PROJECT: Boone Central Athletic Complex Phase 2 **PROJECT NO.** L13015.1
LOCATION: Albion, NE **DATE:** 09/05/13
ADDENDUM NO. 2

BOONE CENTRAL PS - ATHLETIC COMPLEX - PHASE 2

NORTH
A1.2R

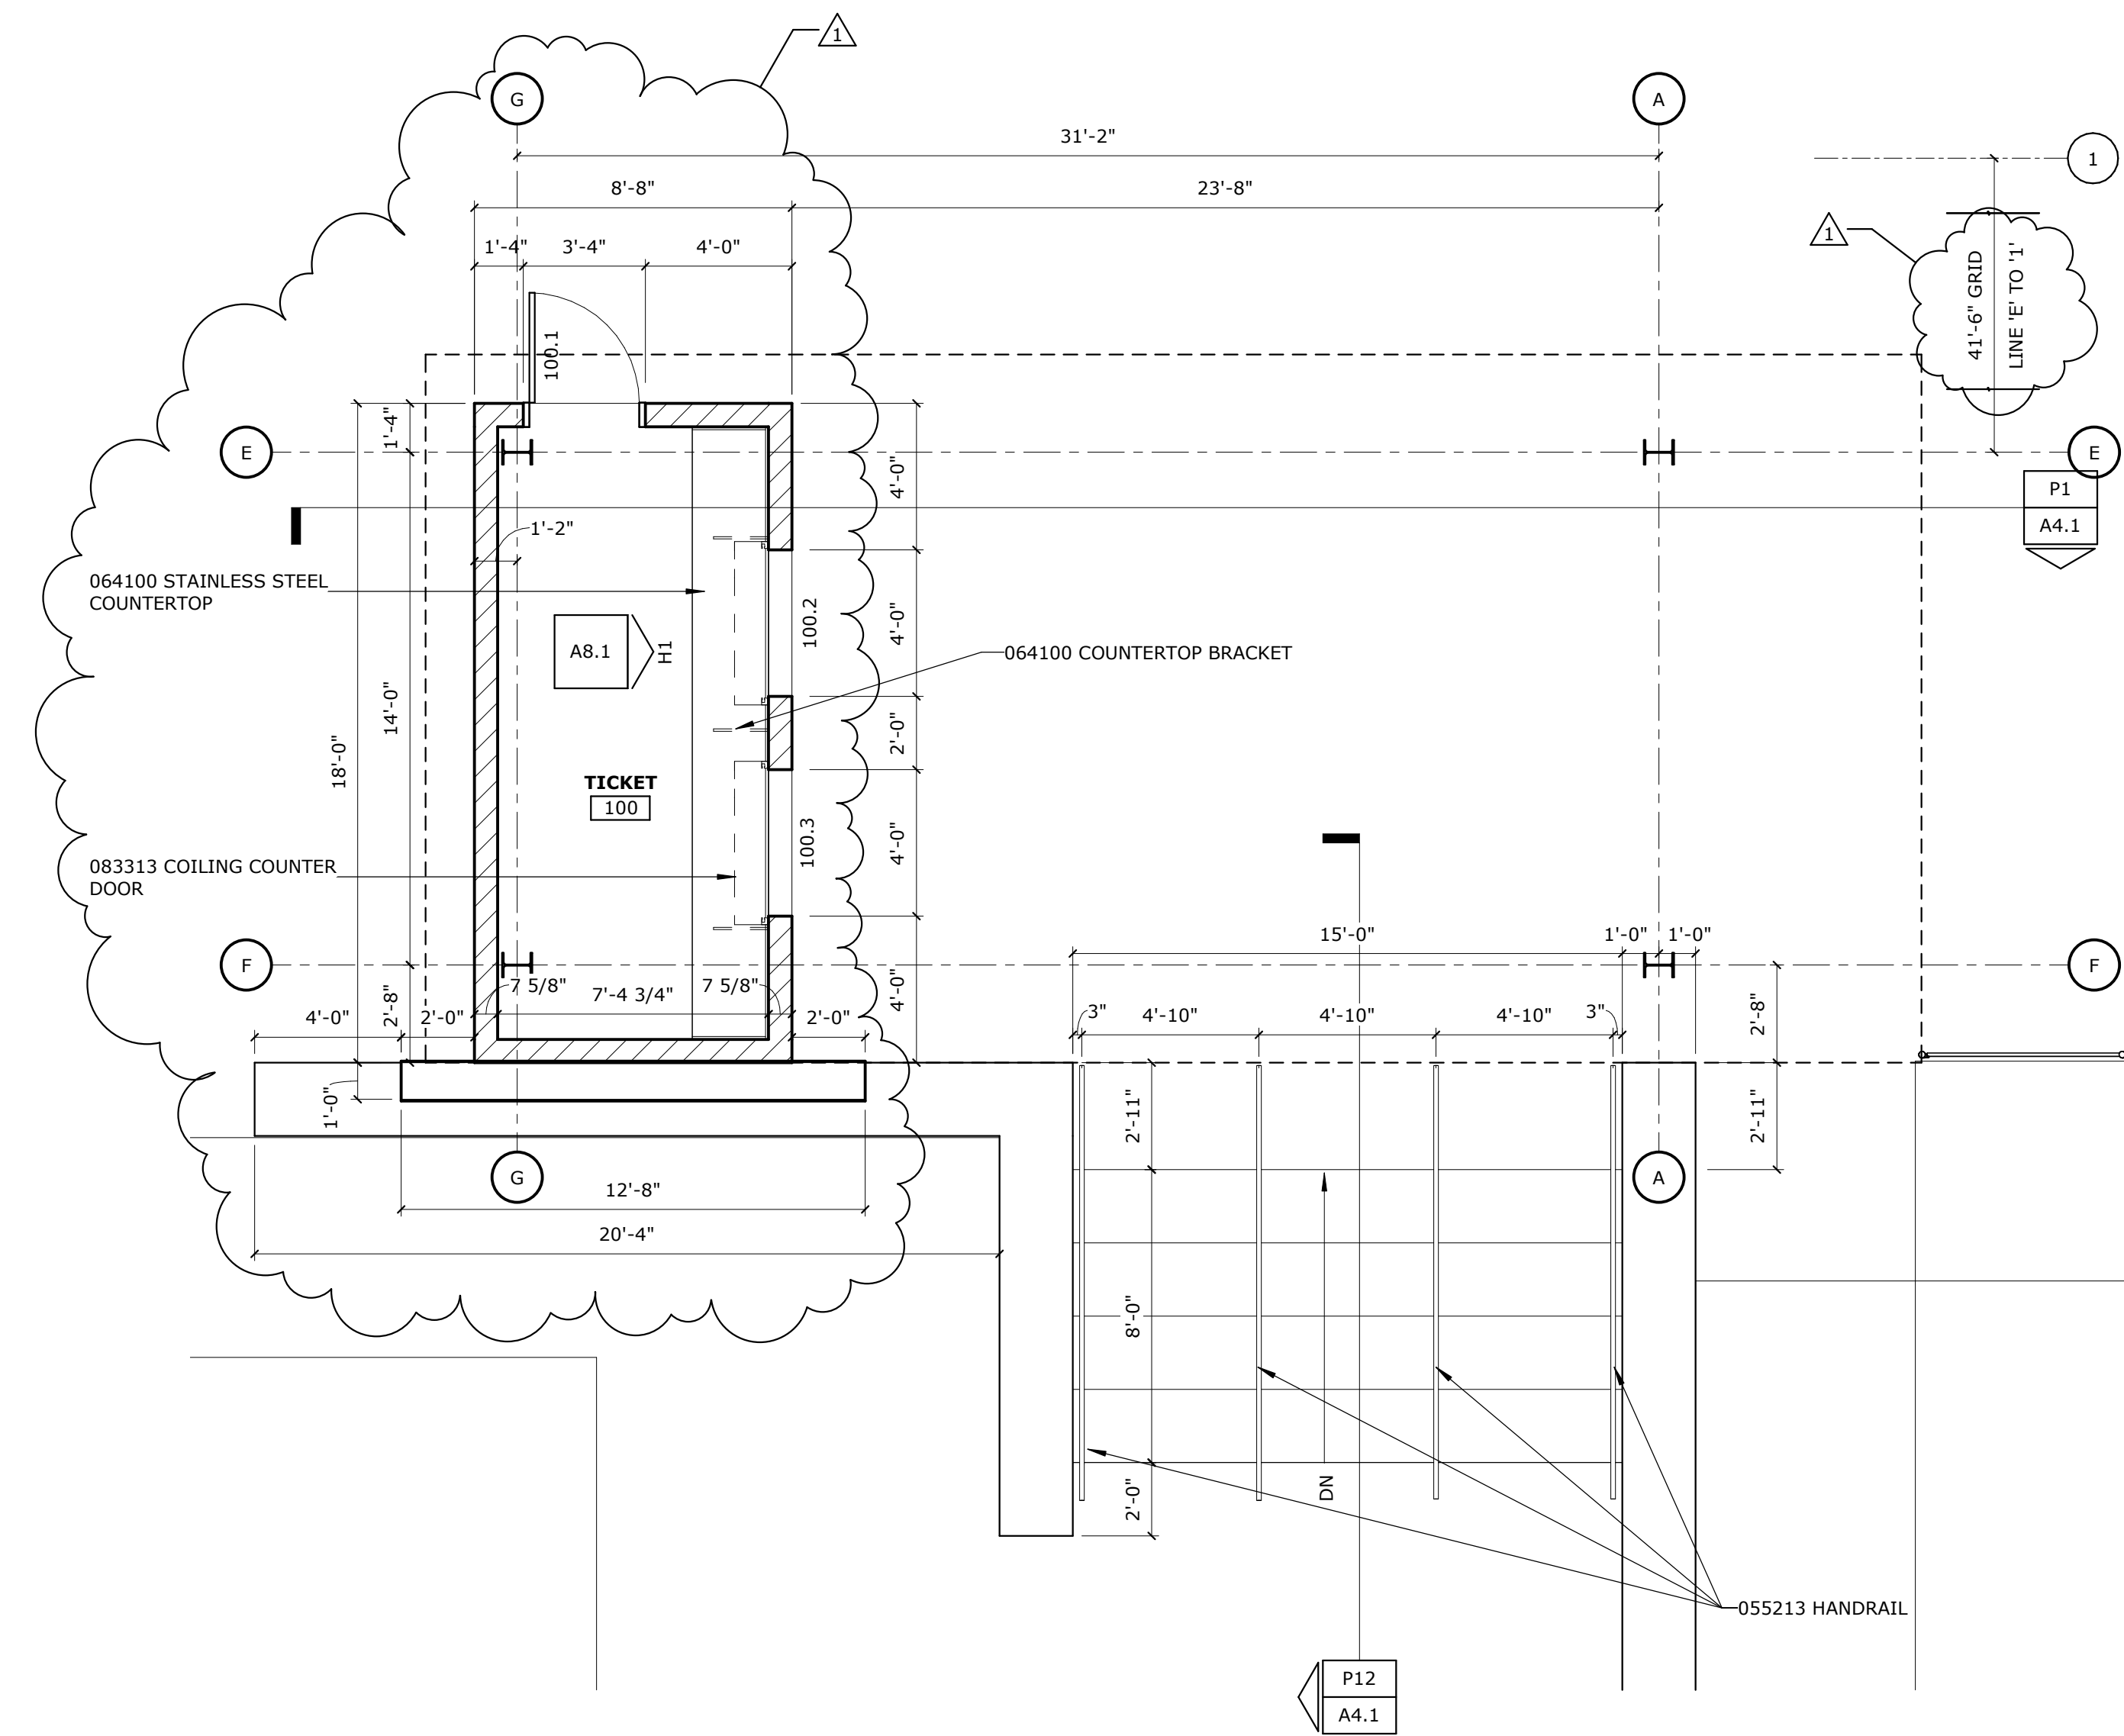
- 1. SHEET A1.2 – ENLARGED FLOOR PLANS
 - a. Replace Sheet A1.2 with included A1.2R.
 - b. Notable Changes in plan include:
 - i. Ticket Booth Door now swings out, and shifted door 4" East

- ii. Shifted Ticket Booth 2'-0" South.
 - iii. Adjusted Signage Wall to consist of a 12" Metal Building Wall with 12" columns and 12" Gurts. Metal Wall Panel on the North and West Sides, Jamb flashing on Ends, Cap flashing on top.

- iv. The signage wall now sits on the Concrete wall which has been extended to the West.
 - v. Grid line 'E' has been added as well as 2 columns in the ticket booth that will support the Metal Building Roof Above.

- vi. The Restroom building has adjusted:
 - 1. Grid Line "B" (and corresponding columns) have shifted 1'-4" East.
 - 2. The east most wall of the Restroom Chase has shifted 2'-0" East.

- 3. The sidewalk adjacent to the East Restroom Chase Wall will shift 2'-0" East as well.
 - 4. The Roof will extend 2'-0" to the east at that location

- vii. The Sectional Garage Door 107.2 in Storage 107 will shift 2'-0" to the South.
